Project:	2022-RFT-030 821131– Solid Waste Landfill Construction		
Addendum No.	02	No. of Pages:	8
Date:	2022-05-13	Doc. No.:	P7201-1591092266-153(1.0)

The purpose of this Addendum is to clarify and answer for bidder's question on tender 2022-RFT-030 issued for bid on April 19, 2022

Item 1A

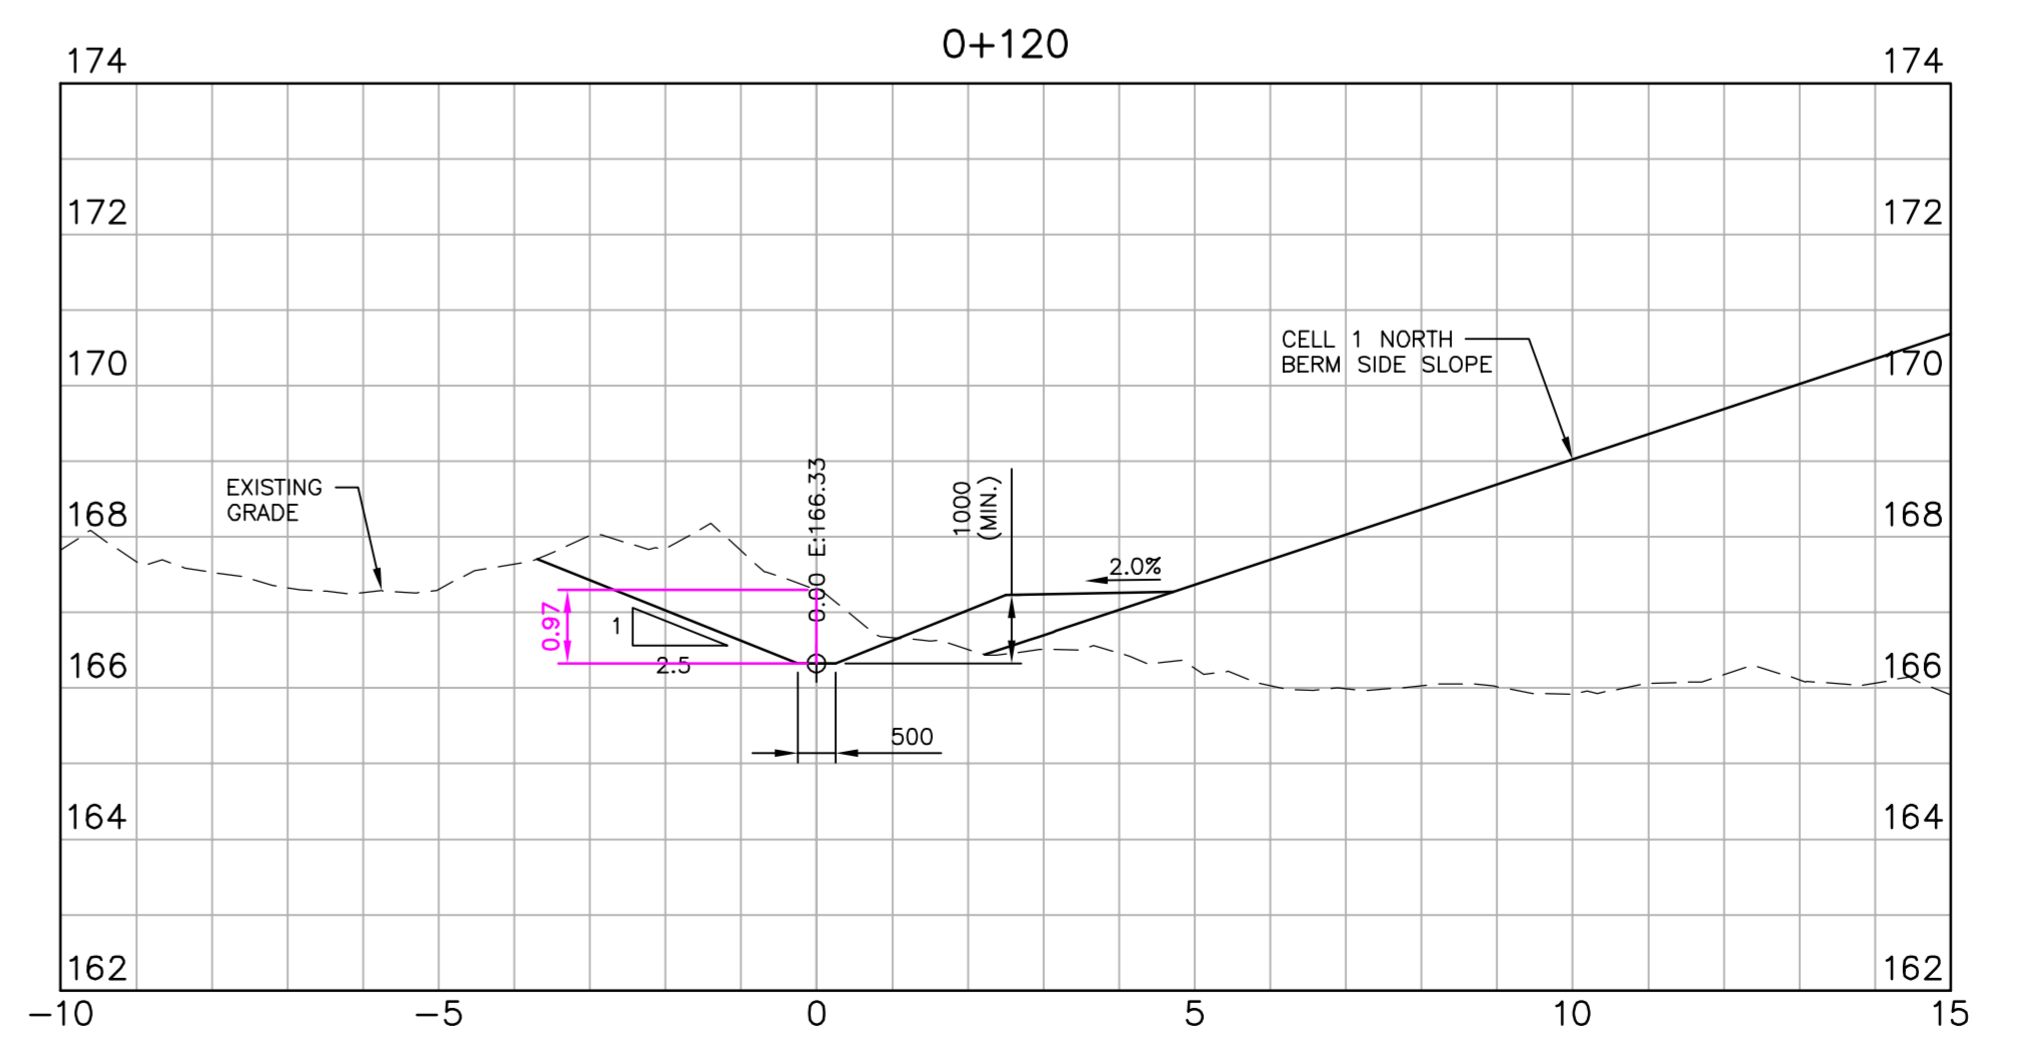
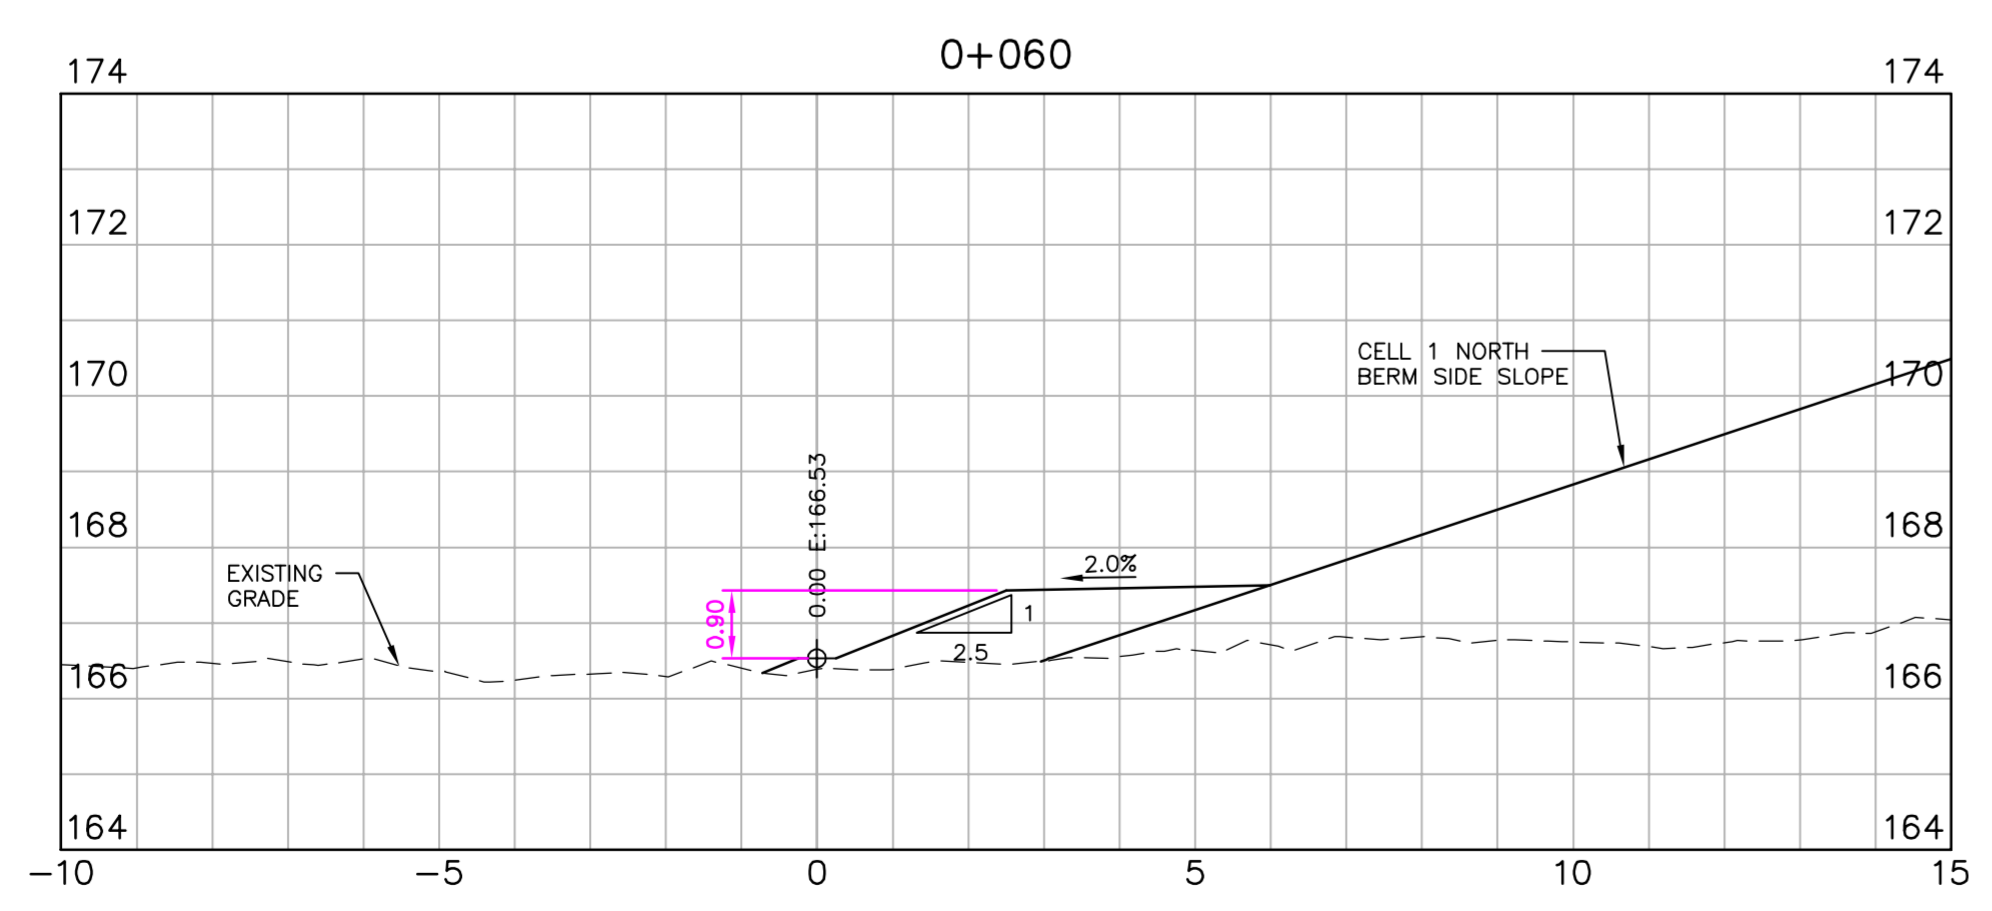
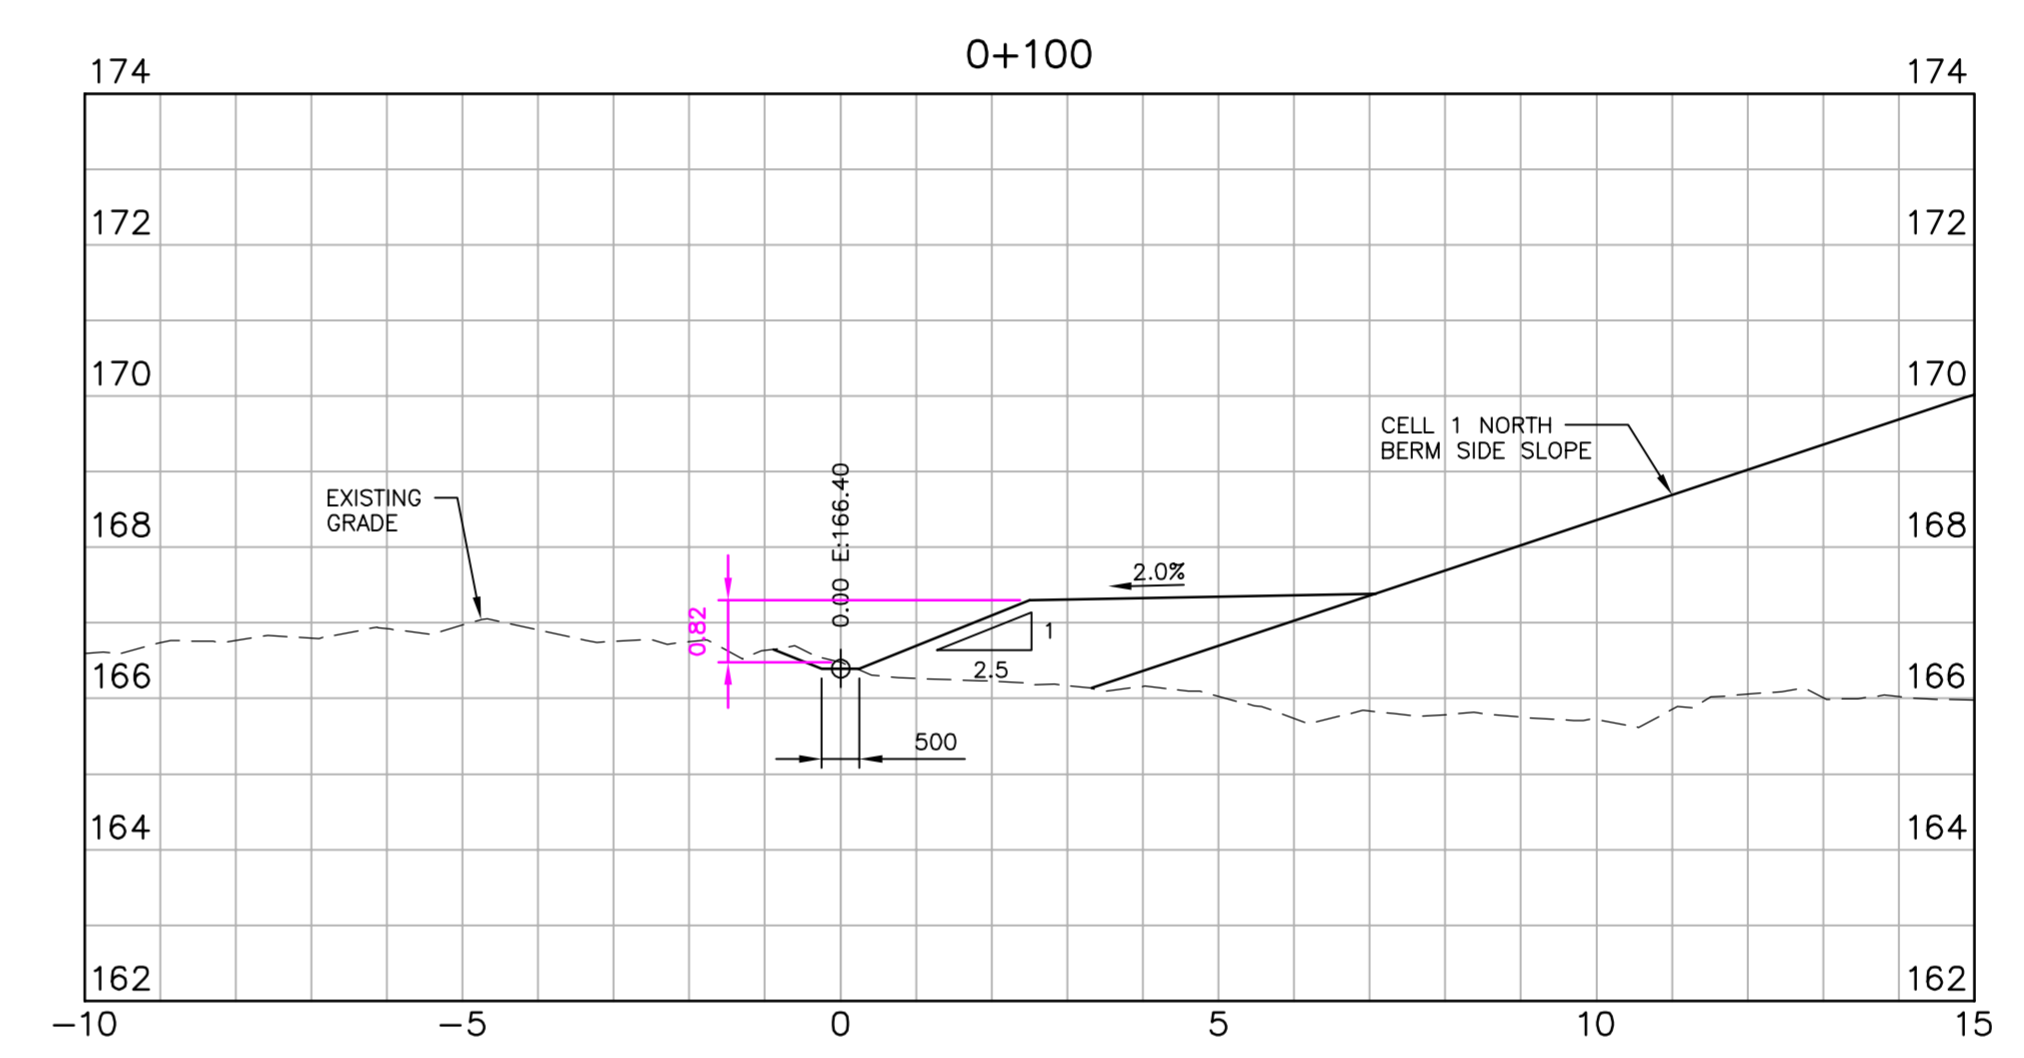
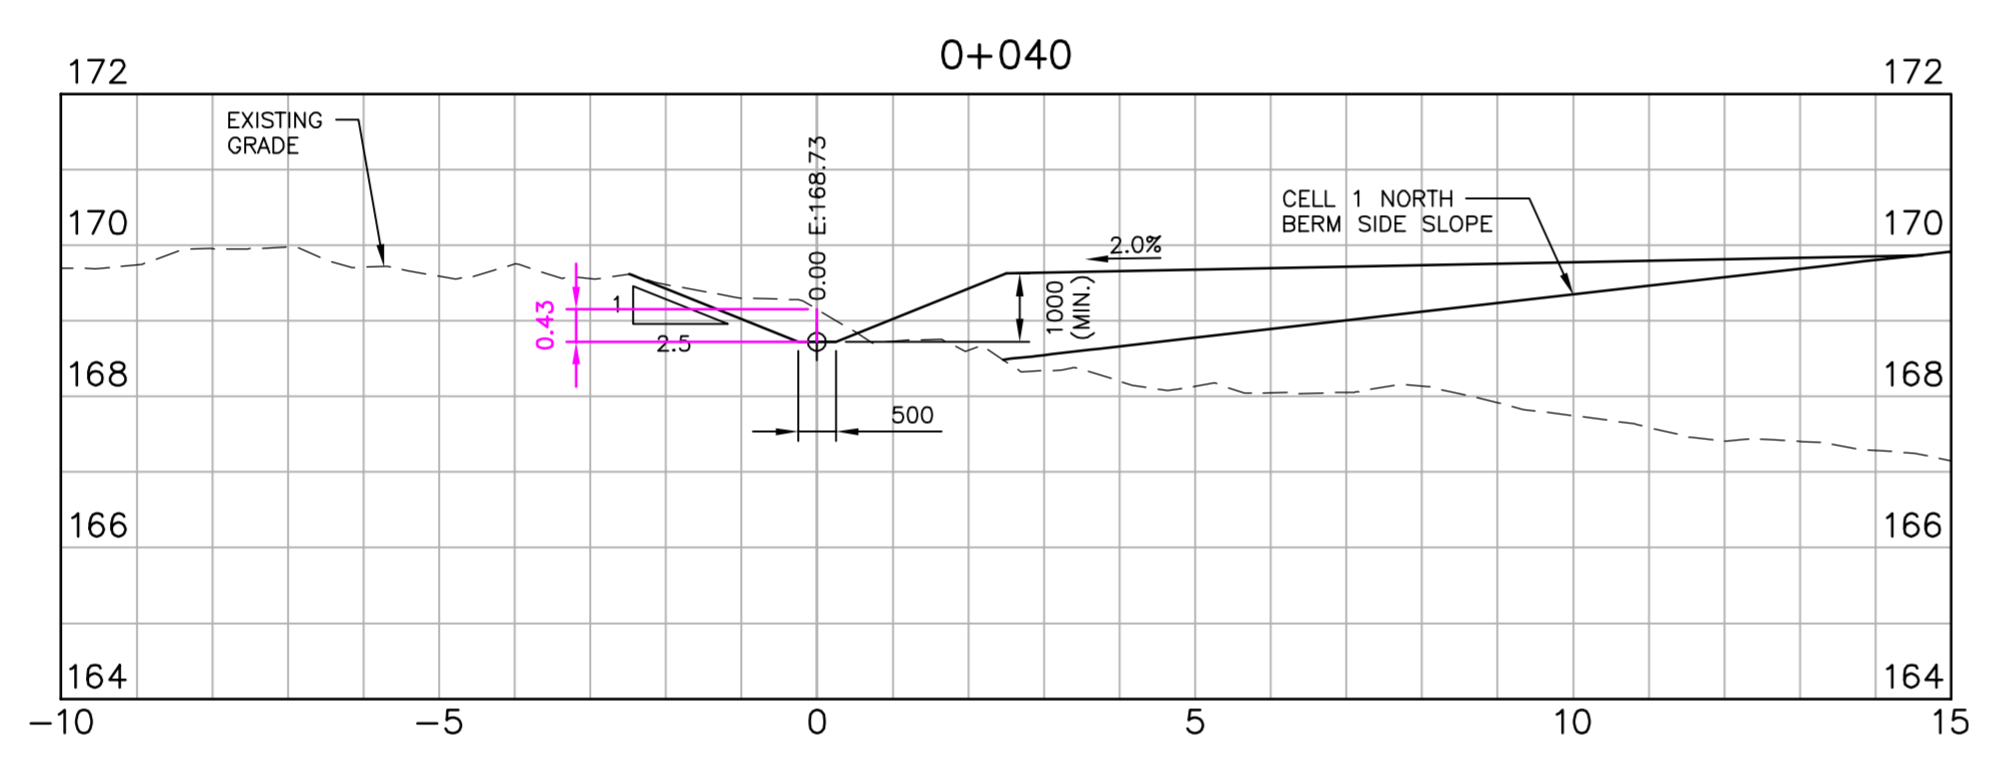
Please confirm limits of liner and geotextile for ditch as width is not clear ([Cell 1 Ditch Liner and Geotextile RFI.pdf](#))

Please see attached Item 1A and 1B.
